ATTACHMENT (4)

MARKED-UP PAGES

**PRE-OUTAGE AND POST-OUTAGE
ENGINEERED SAFETY FEATURES ELECTRICAL SYSTEM
CONFIGURATION**

FIGURE 2, POST-OUTAGE ELECTRICAL DISTRIBUTION CONFIGURATION

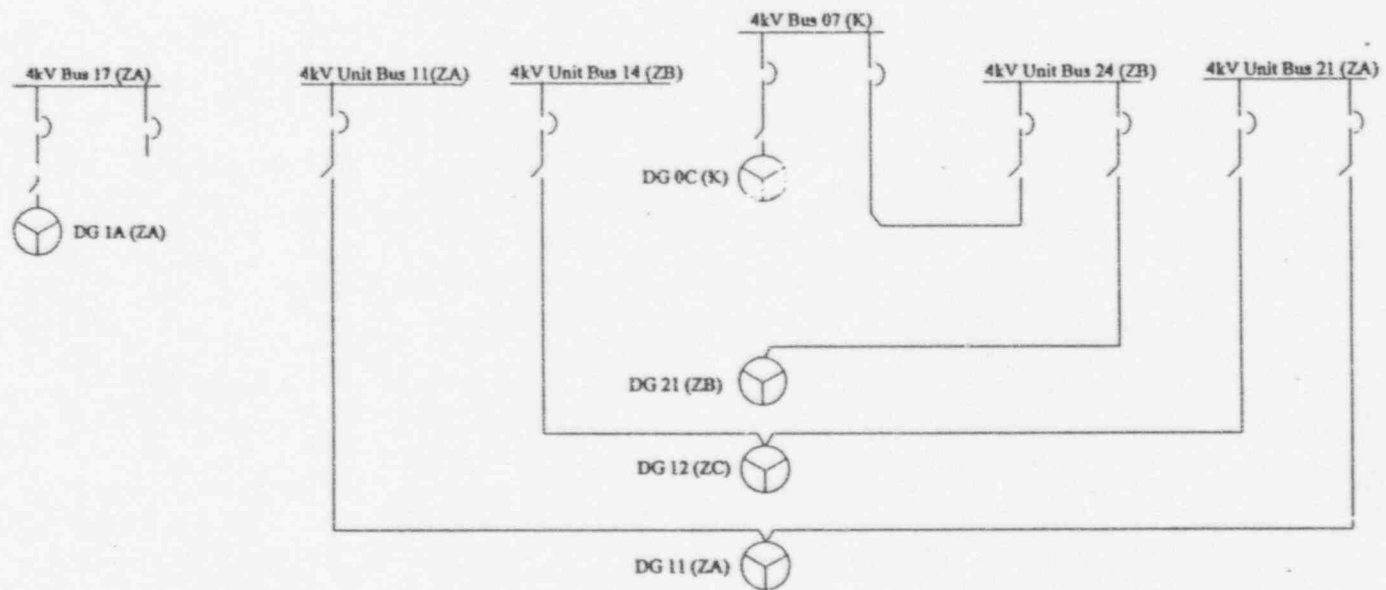
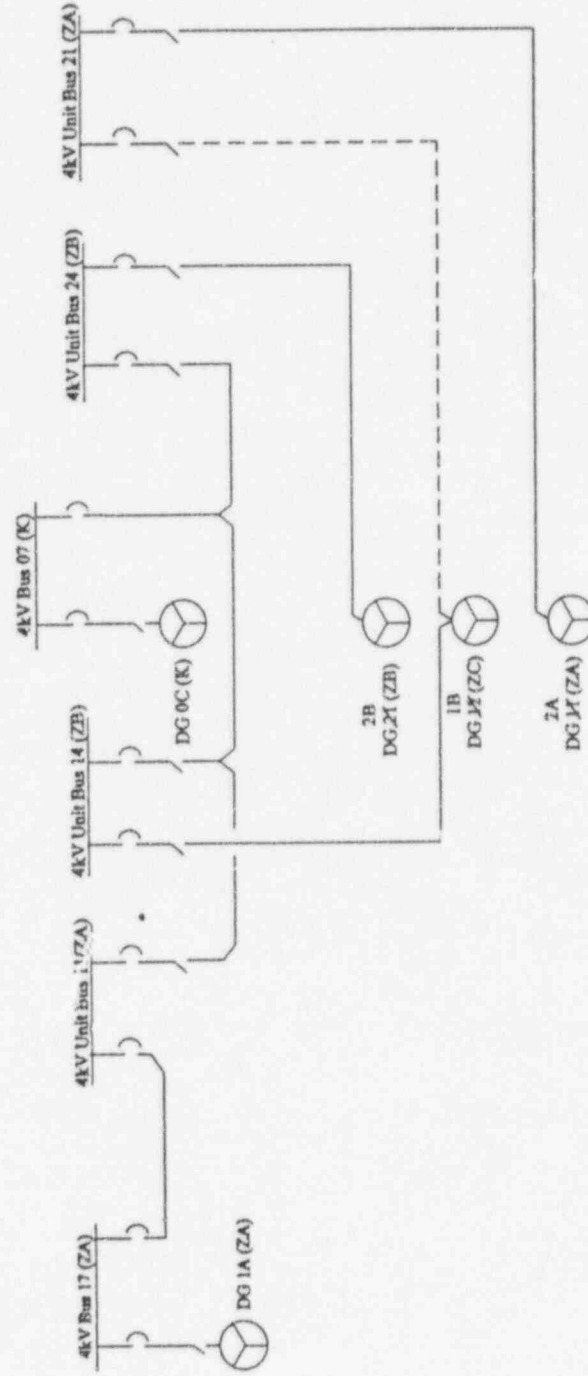
--- Auto-start, auto-load capability has been eliminated.
